Reference: Final Roadway Exploration Report

BRO-62-27.49 PID No. 114435

Eagle Township, Brown County, Ohio

FINAL ROADWAY EXPLORATION REPORT

GEOTECHNICAL PROFILE - US 62 STA. 1445+50.00 TO STA. 1456+50.00

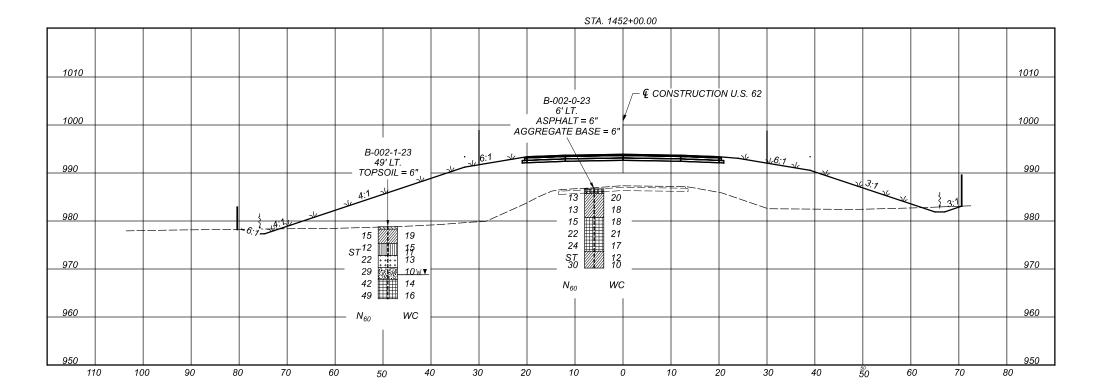
- 2. Geotechnical Profile:
 - a. Sheet 7 for future reference, showing an offset boring in a cross section (as was done on the next sheet) is OGE's typical practice (as opposed to also duplicating the graphical log for B-002-1-23 in an offset box on the plan/profile sheet).

CTL Response: The offset boring has been removed from Sheet 7 of the final soil profile sheets.
